Report to the Future Melbourne (Planning) Committee

Agenda item 6.1

**Planning Permit Application: TP-2015-1203
28-32 Albermarle Street, Kensington**

20 August 2019

Blank walls visible above the adjoining four storey townhouses

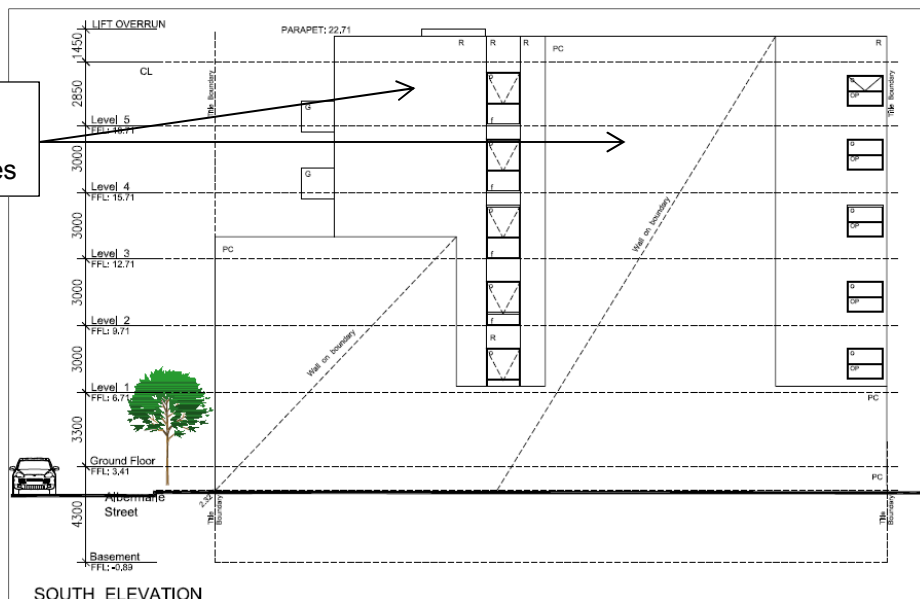
It is policy that building forms and surface treatments are appropriately articulated to moderate apparent bulk and mass and avoid blank walls. The street frontages are appropriately articulated. The blank wall on the east boundary will abut a simultaneously constructed wall at 51-61 Hardiman Street (TP-2016-1039). The blank walls on and adjoining the south boundary will be visible above the adjoining four storey townhouses also at 51-61 Hardiman Street (TP-2016-1039). A condition is recommended to ensure that the building is designed ‘in the round’ and the blank walls are moderated by an appropriate façade treatment.

1. Prior to the commencement of the development, two copies of plans, drawn to scale must be submitted to the Responsible Authority, generally in accordance with the drawings by Point Architects dated February 2019, but amended to show:
 - a) A façade strategy for the south elevation to demonstrate that it is appropriately articulated and does not present blank walls above the approved townhouses at 51-61 Hardiman Street.

Interface between the proposed development and the approved development at 51-61 Hardiman Street (Source: Plus Architecture)

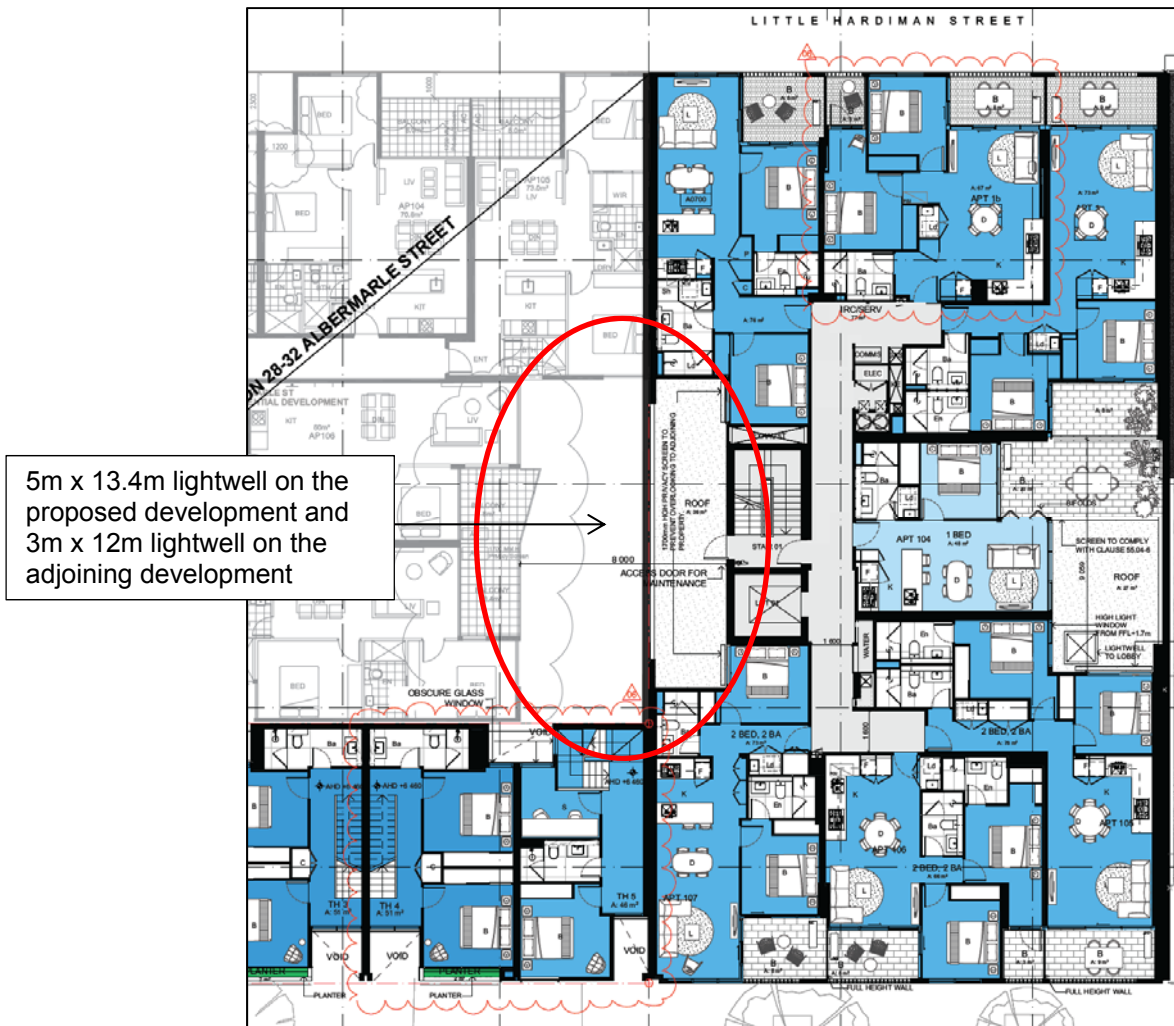
The development will not unreasonably affect the amenity of the approved apartment building at 51-61 Hardiman Street (TP-2016-1039), which has a 3m wide x 12m long lightwell adjoining the site. The core provides a solid wall for the most part, the habitable room windows to the north and south have 1.7m high privacy screens. The proposed development has a 5m wide x 13.4m long lightwell. The 8m separation provides adequate light for both buildings and outlook for the east-facing apartments within the proposed development.

Condition 1 amended plans are recommended to ensure that the terrace to APT301 and the west-facing bedroom windows to APT306, APT406 and APT506 do not have direct views of, or are screened to limit direct views of, the rooftop terraces of the approved townhouses at 51-61 Hardiman Street (TP-2016-1039).

- b) The terrace to APT301 and the west-facing bedroom windows to APT306, APT406 and APT506 screened to limit direct views of the rooftop terraces to the approved townhouses at 51-61 Hardiman Street or plans that clearly demonstrate that screening is not required.
- c) No cooling or heating units located on balconies less than 9.5m².
- d) Any changes as required by the revised Waste Management Plan required in condition 21.
- e) 1:20 drawings of the fenestration and façade details at key junctions.
- f) Outward opening doors onto the public realm redesigned to comply with Council's Road Encroachment Guidelines.
